PORTLAND GENERAL ELECTRIC COMPANY

Trojan Nuclear Plant
Docket 50-344
License NPF-1

CLARIFYING INFORMATION TO SUBMITTALS ENTITLED

TROJAN CONTROL BUILDING
SUPPLEMENTAL STRUCTURAL EVALUATION
SEPTEMBER 19, 1978

Figure 12-1 Equivalent Elasto-Plastic System Based On The Newmark Criteria

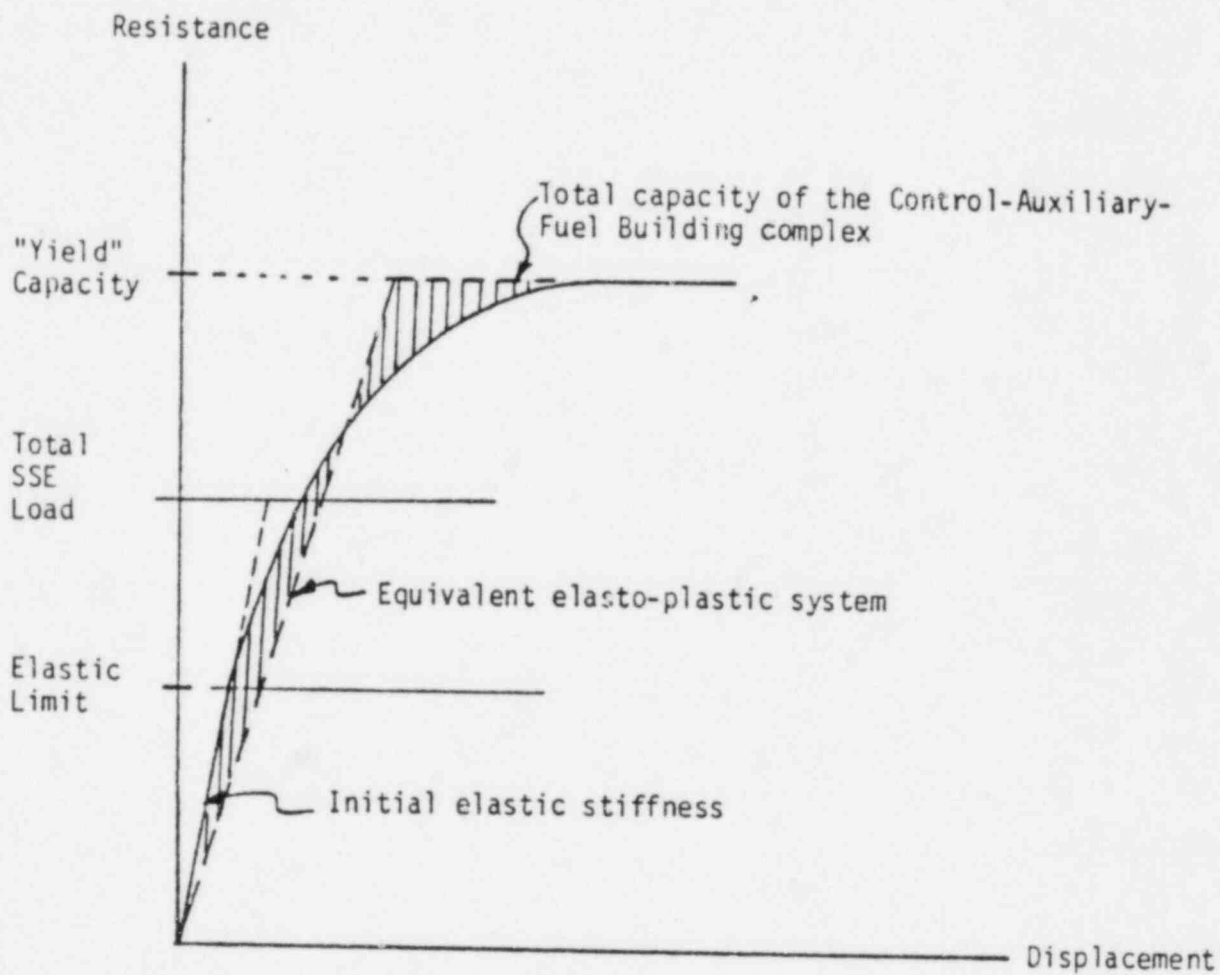
"Provide justification for using the ductility ratio of 1.5 in the discussion on Page 3b-2 of the response to NRC questions. Show why it is conservative and why it is consistent considering the information in Appendix D for both frequency shifts and reductions in amplitude."

the criteria given in Appendix E in this case would be less than one; see attached Figure 12-1). The ductility ratio of 1.5 used in the response to the NRC question 3(b) was selected as an upper bound to illustrate the possible effect of the Control Building inelastic response on the response of the total system.

Due to the Control Building inelastic behavior, the total stiffness of the entire building complex will be somewhat lower than the initial elastic stiffness. However, the reduction of the total stiffness is expected to be not more than one-half of the total initial stiffness because under the SSE load the Fuel Building end of the structural complex still remains in the elastic range. Thus, the lowering of the system frequency due to the Control Building inelastic behavior is expected to be not lower than $f/1.414$, where f is the STARDYNE system frequency. This shifts the frequency into the frequency range of the original floor spectral peak, as shown in the response to question 3(b).

Key to wall numbers

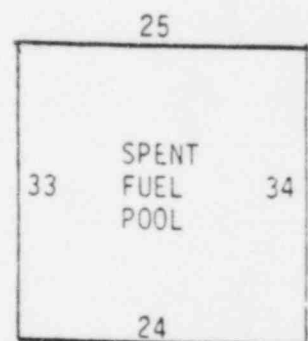
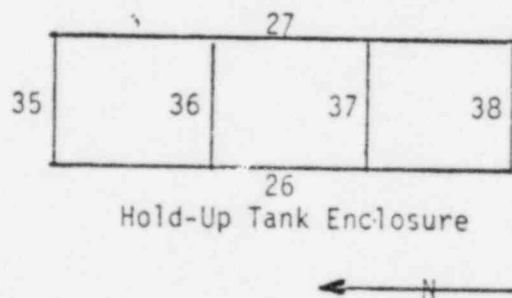
"For Table 2.1 on Page 2-4 of the response to NRC questions specify the moment and the shear capacities of Fuel Building walls according to ACI 318-63. Include a statement that the 1963 code is met in total for those walls."

"Relative to the Fuel Building walls where you used ACI 318-77, are all provisions of that code met?"

Strength" defined by the ACI 318-63 code are identical.) The ACI 318-63 code did not include specific provisions for calculating shear strength of shear walls. The values in the table under "Ultimate Shear Strength" are based on $2\sqrt{f'_c}$ shear stress, 0.85 capacity reduction factor and specified design strength (not "as-built" strength) of materials. In computing the "d" value (distance from extreme compression fiber to the centroid of tension reinforcement), a flange width extended to the centerline between two walls, the reinforcement in the tensile flange and two thirds of the reinforcement in the web were considered. Since formulae (17-2) and (17-3) of the code have not been used, additional conservatism was introduced. Based on these parameters, most of the "Ultimate Design Strengths" as defined by the ACI 318-63 code are slightly lower than the "Design Shear Strength" based on the ACI 318-77 code. However, even these lower strengths are higher than the loads derived from both the original stick model analysis and the STARDYNE analysis based on factored load condition.

The revised table also provides information on shear strengths governed by ultimate resisting moments. The calculation of these values has been based on the ACI 318-63 code as described above. Since both the hold up tank enclosure structure and the fuel pool are "box" type reinforced concrete structures, with 0.6-0.8 percent reinforcing steel, the moment capacity of these walls are high. There is only one wall for which the shear strength is governed by ultimate resisting moment.
